PLANNING RESPONSES
SUNLIGHT HOUSE
APRIL 2023

EXTERNAL ALTERATIONS

INTERNAL ALTERATIONS

Drawing Title
Proposed Reflected Ceiling Plan - Level 11

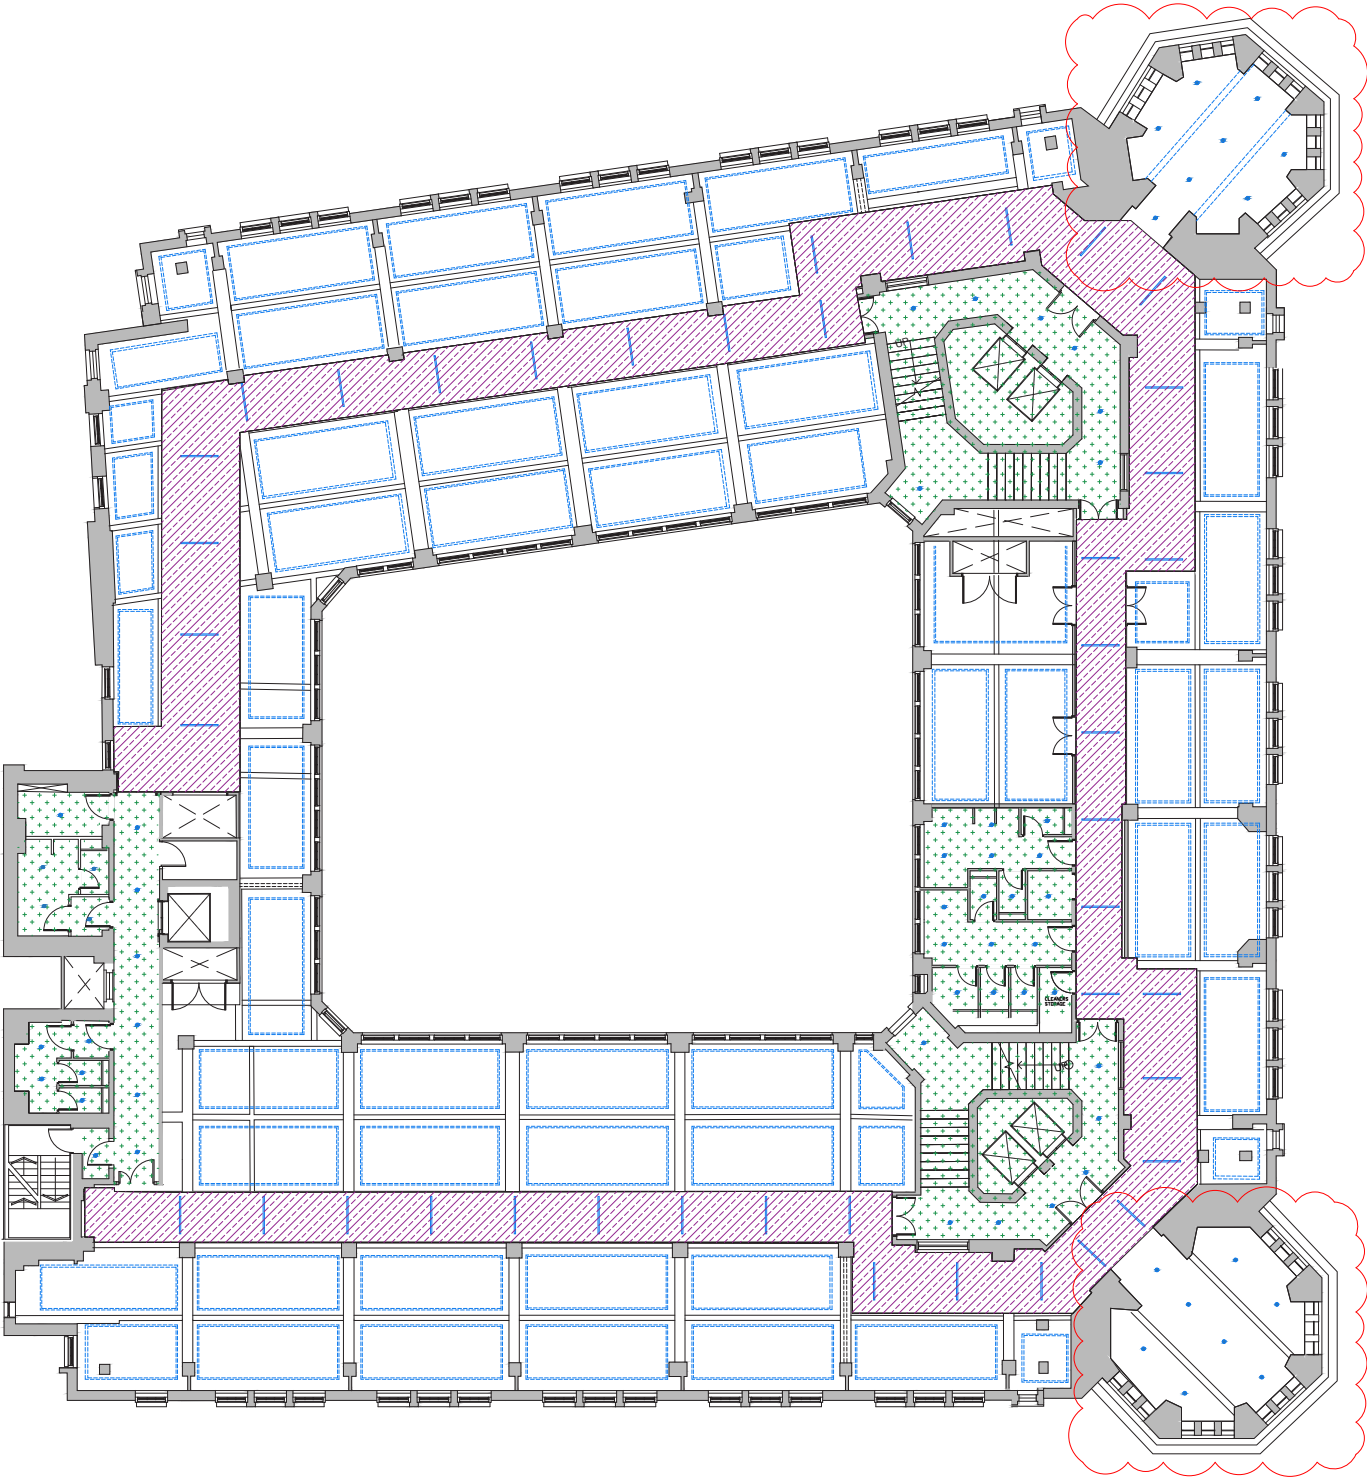
We need to review the most recent ceiling plans. The previous information did not show the areas of the existing suspended ceilings across the interior of Sunlight House and therefore it has not been possible to review whether the proposed changes would be better or worse than the current situation.

We believe this has now been responded to - all comments noted on the additional information required and areas that were mislabeled.

All have been agreed with aside from necessity of maintaining dropped ceiling in WC core.

Drawing Title
Proposed Reflected Ceiling Plan - Level 12

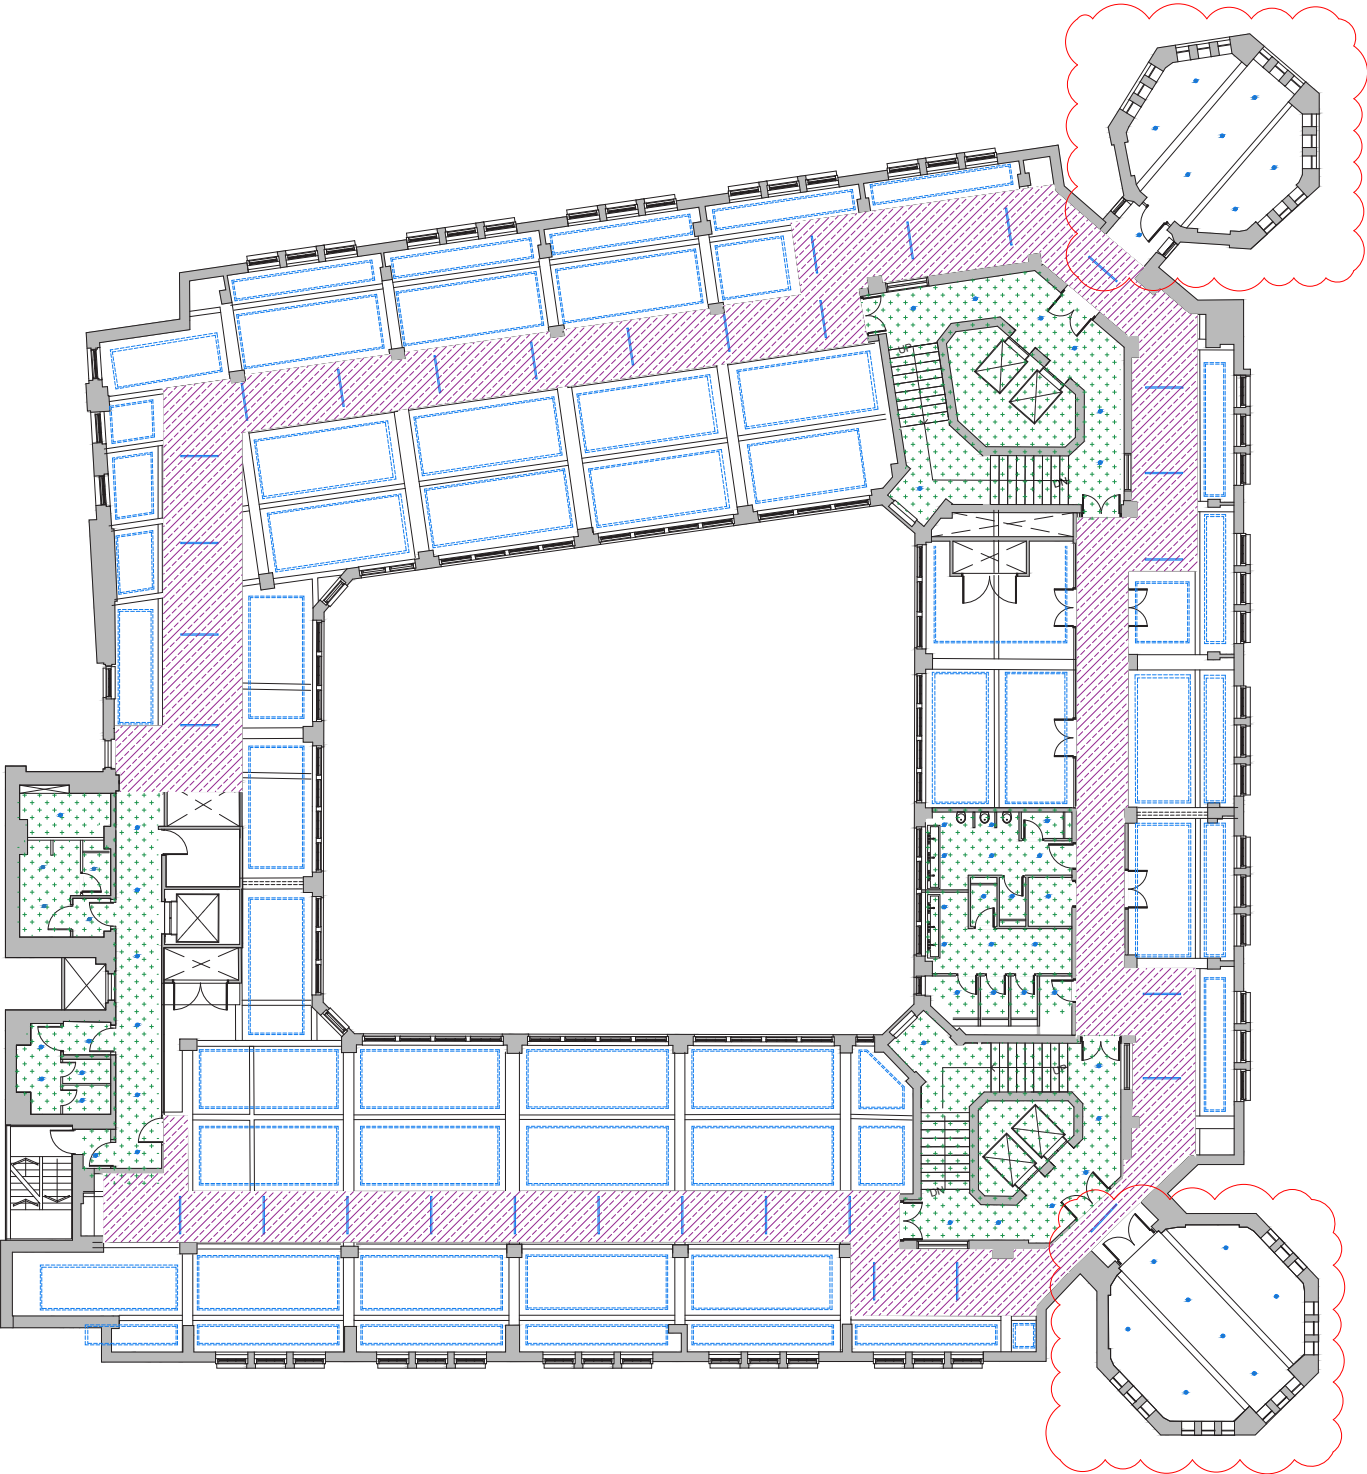
We need to review the most recent ceiling plans. The previous information did not show the areas of the existing suspended ceilings across the interior of Sunlight House and therefore it has not been possible to review whether the proposed changes would be better or worse than the current situation.

We believe this has now been responded to - all comments noted on the additional information required and areas that were mislabeled.

All have been agreed with aside from necessity of maintaining dropped ceiling in WC core.

Drawing Title
Proposed Reflected Ceiling Plan - Level 13

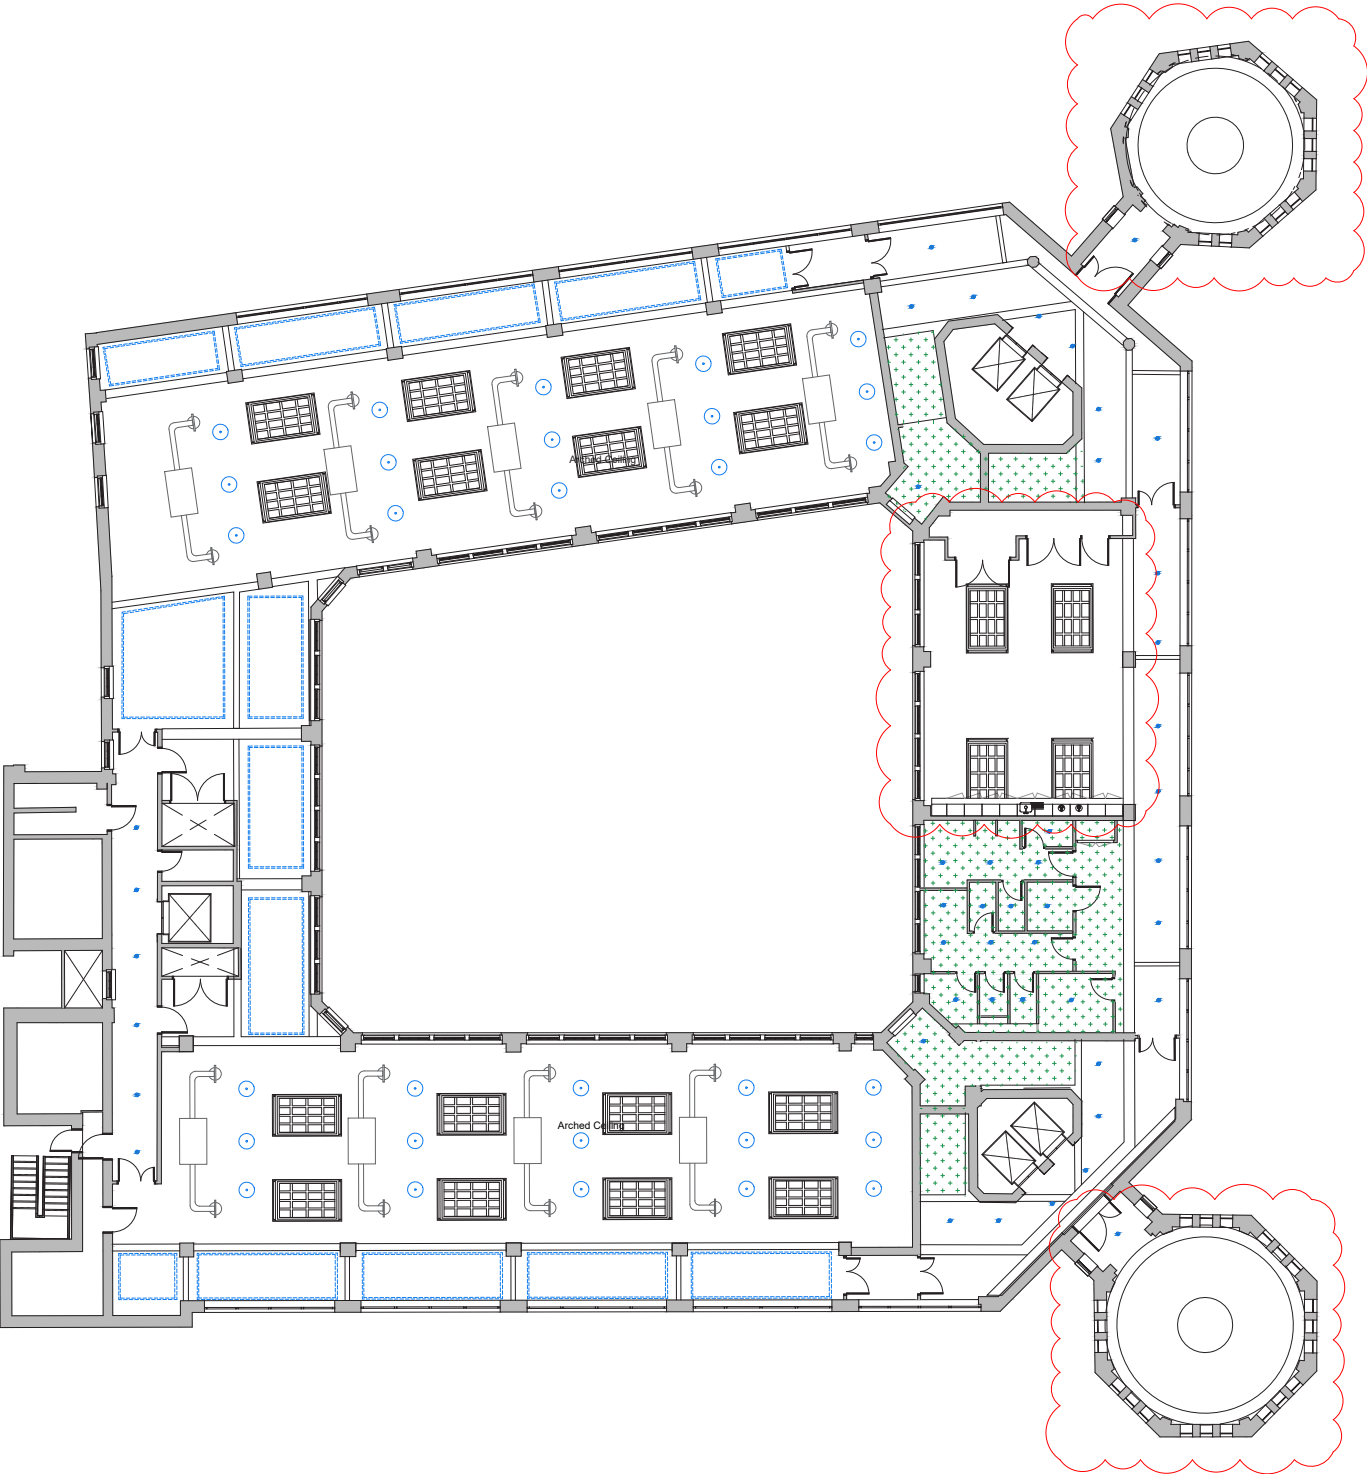
We need to review the most recent ceiling plans. The previous information did not show the areas of the existing suspended ceilings across the interior of Sunlight House and therefore it has not been possible to review whether the proposed changes would be better or worse than the current situation.

We believe this has now been responded to - all comments noted on the additional information required and areas that were mislabeled.

All have been agreed with aside from necessity of maintaining dropped ceiling in WC core.

LEVEL 08 - EXISTING

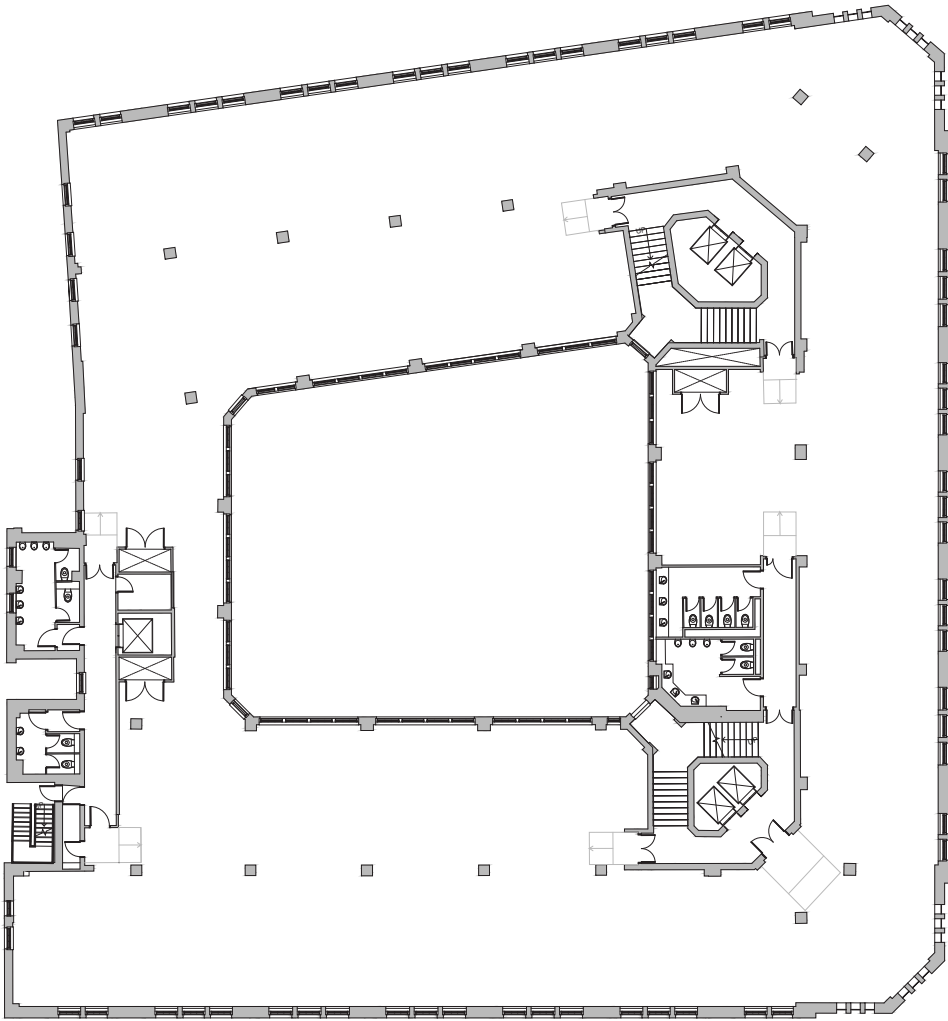
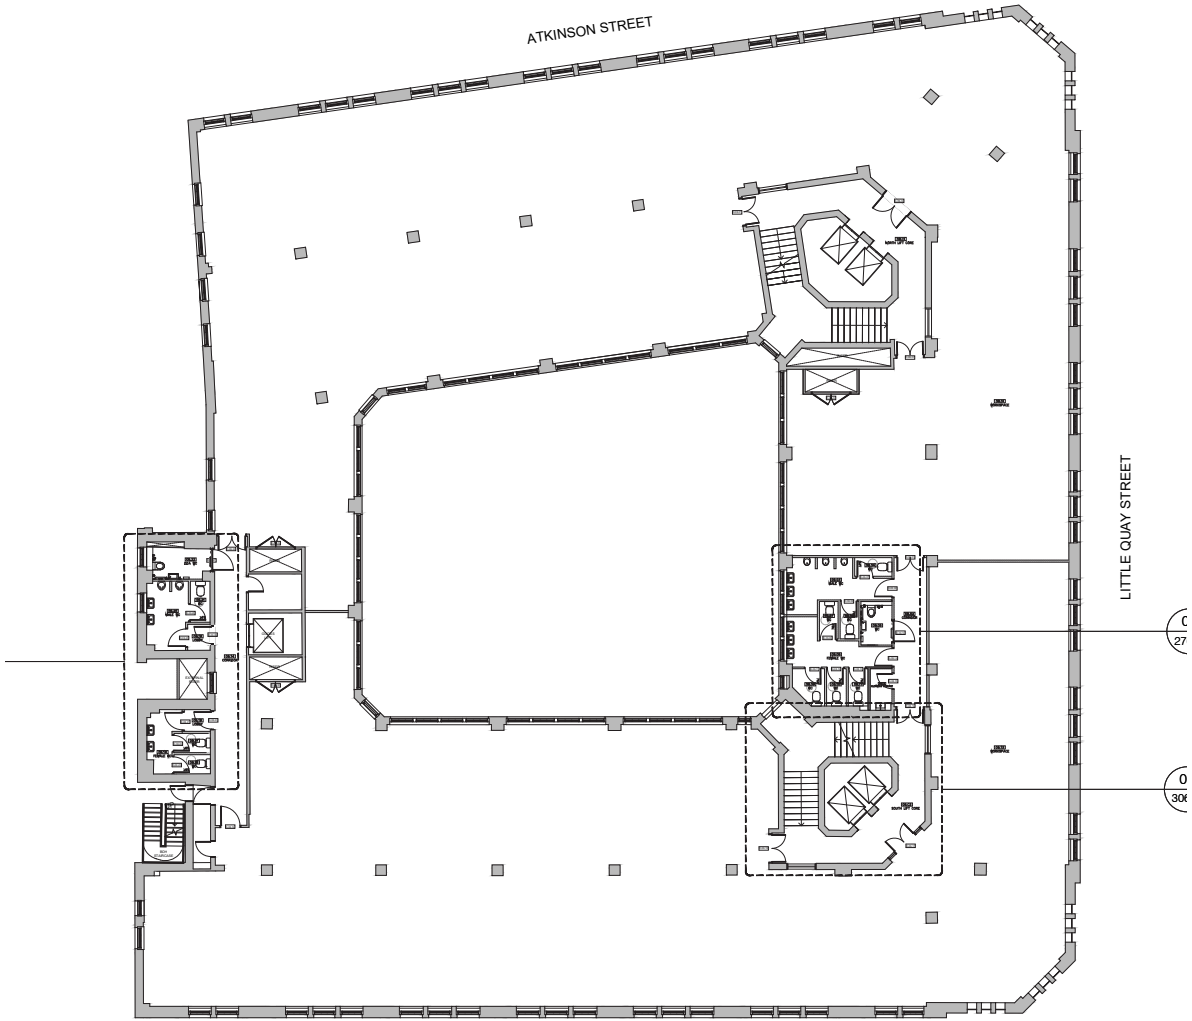
The service risers across the interior and the proposed works to the areas where existing service risers are to be removed needs to be better understood. Relevant cross sections, work specifications and photographs of the affected areas should be submitted. .

Generally speaking the riser strategy looks to maintain and utilise existing risers where possible. In the areas where we are amending existing we would look to make good in a similar way to that was approved on level 8 previously.
